SERVICE BULLETIN

N° **139-757**

**ATA 62 - MAIN ROTOR RETROMOD P/N 3G6200P00111 INSTALLATION**

This Service Bulletin is issued in order to provide the necessary instruction on how to perform the installation of retromod P/N 3G6200P00111, related to a new Main Rotor Head configuration, consisting in the replacement of washer, nuts, bolts and retaining element assy.

**Figure 1**

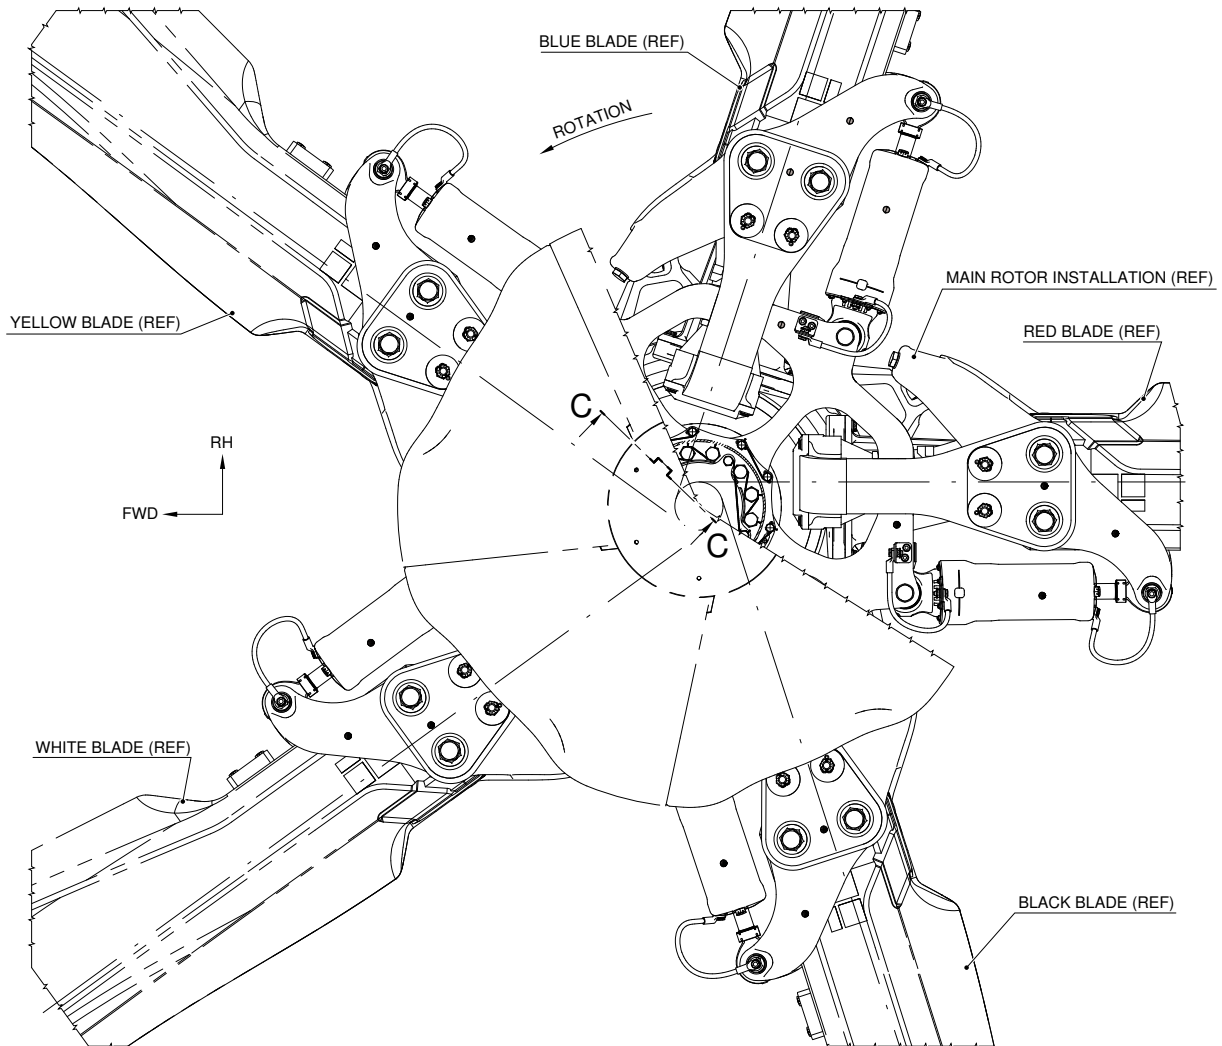
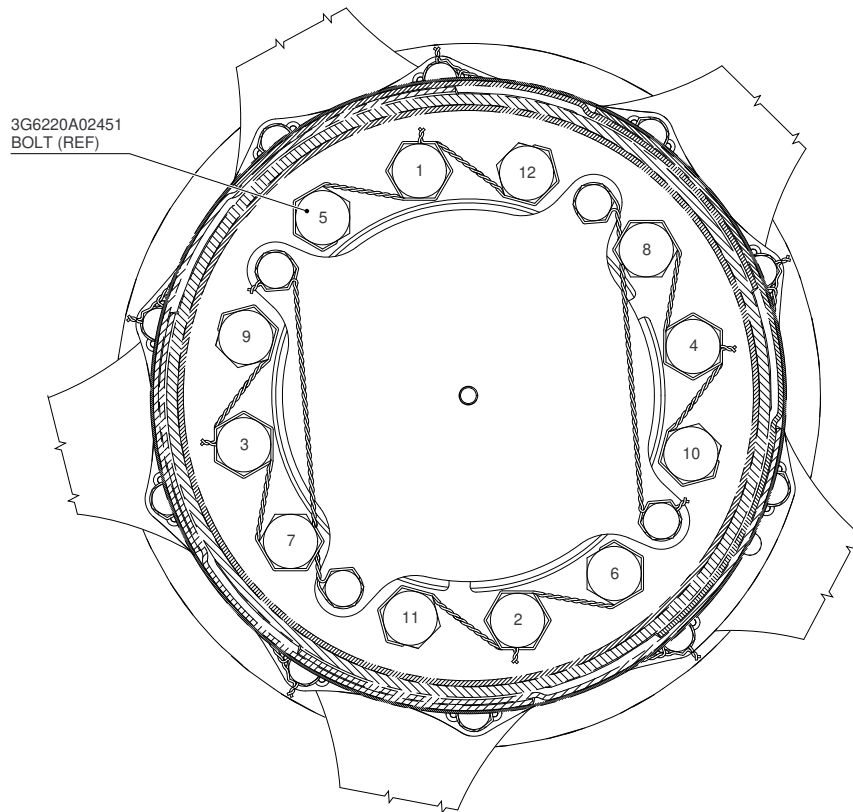
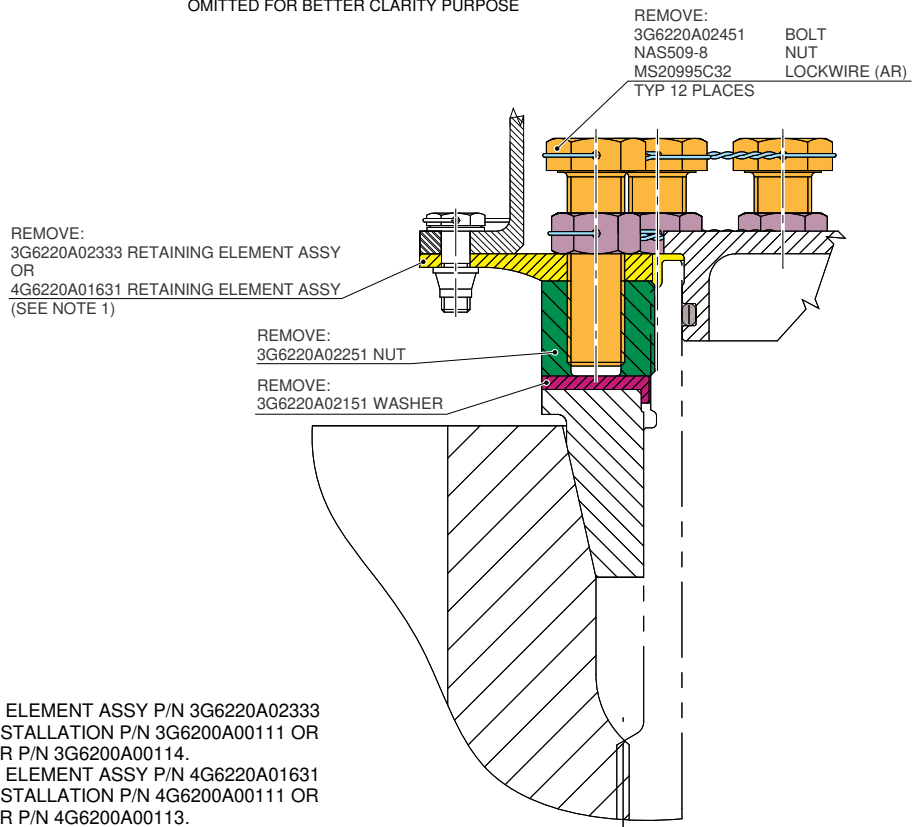
2. In accordance with applicable steps of AMP DM 39-A-62-21-05-00A-520A-A (Configuration A) and with reference to Figures 1 and 2, remove from the main rotor head the following components:
  - washer P/N 3G6220A02151;
  - nut P/N 3G6220A02251;
  - retaining element assy P/N 3G6220A02333;
  - n°12 bolt P/N 3G6220A02451;
  - n°12 nut P/N NAS509-8.

3. In accordance with applicable steps of AMP DM 39-A-62-21-05-00A-520A-A (Configuration A) and with reference to Figures 1 and 2, remove from the main rotor head the following components:
  - washer P/N 3G6220A02151;
  - nut P/N 3G6220A02251;
  - retaining element assy P/N 4G6220A01631;
  - n°12 bolt P/N 3G6220A02451;
  - n°12 nut P/N NAS509-8.

- 1 REMOVE RETAINING ELEMENT ASSY P/N 3G6220A02333 FOR MAIN ROTOR INSTALLATION P/N 3G6200A00111 OR P/N 3G6200A00112 OR P/N 3G6200A00114.  
REMOVE RETAINING ELEMENT ASSY P/N 4G6220A01631 FOR MAIN ROTOR INSTALLATION P/N 4G6200A00111 OR P/N 4G6200A00112 OR P/N 4G6200A00113.

**Figure 3**

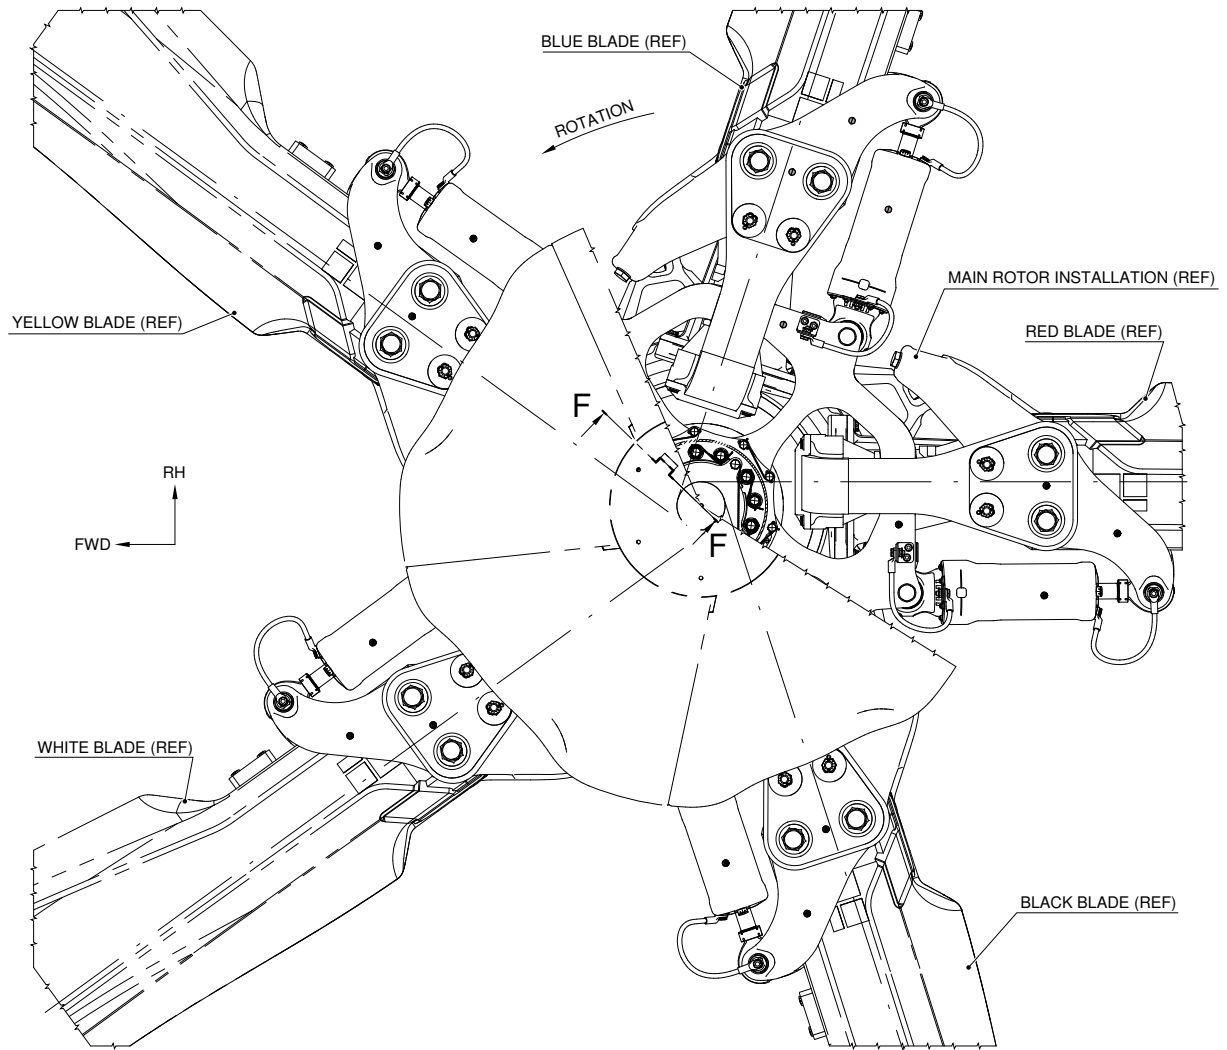
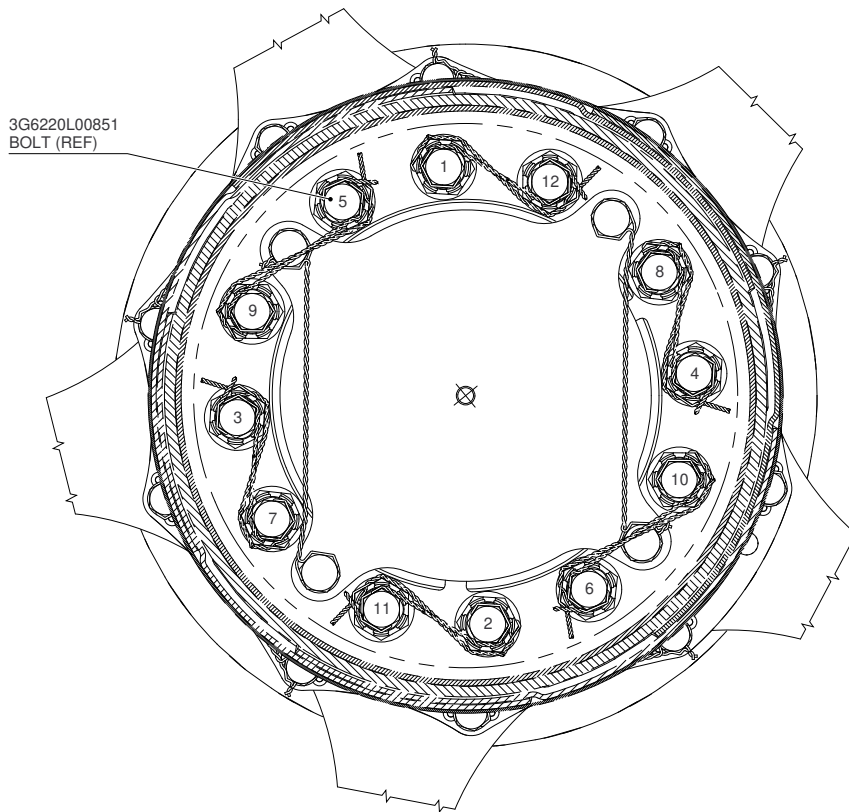
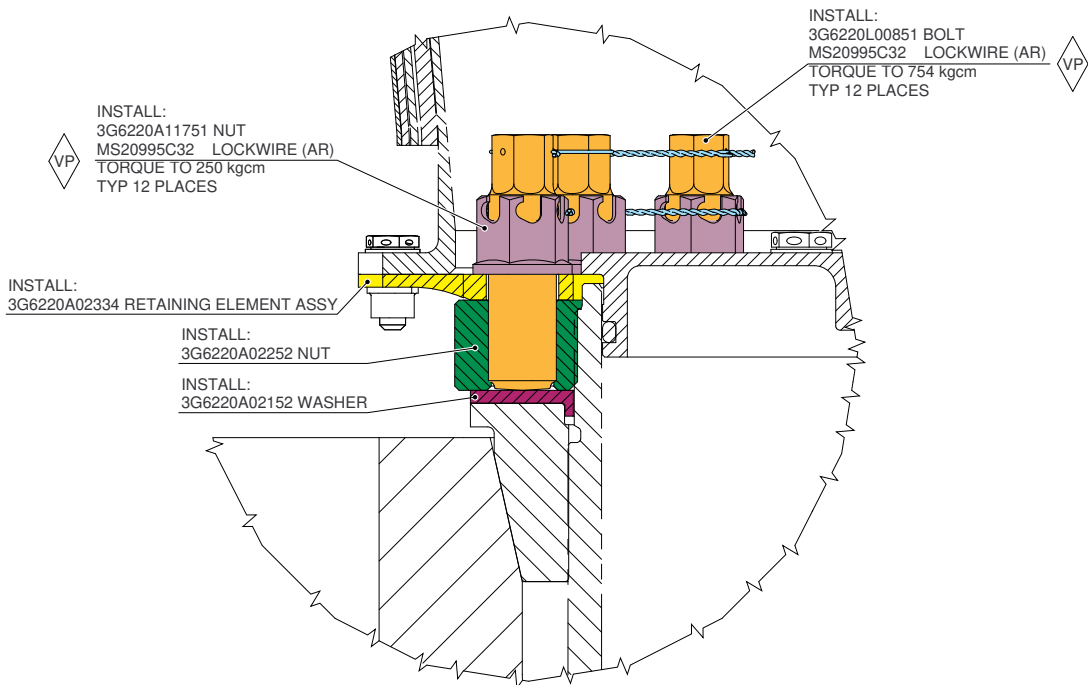
Check the tightening torque and the correct installation of the bolt P/N 3G6220L00851 and the nuts P/N 3G6220A11751.

4. In accordance with applicable steps of AMP DM 39-A-62-21-05-00A-720A-A (Configuration B) and with reference to Figures 3 and 4, install on the main rotor head the following components:
  - washer P/N 3G6220A02152;
  - nut P/N 3G6220A02252;
  - retaining element assy P/N 3G6220A02334;
  - n°12 bolt P/N 3G6220L00851;
  - n°12 nut P/N 3G6220A11751.
5. Return the helicopter to flight configuration and record for compliance with this Service Bulletin on the helicopter logbook.
6. Gain access to My Communications section on Leonardo WebPortal and compile the "Service Bulletin Application Communication".
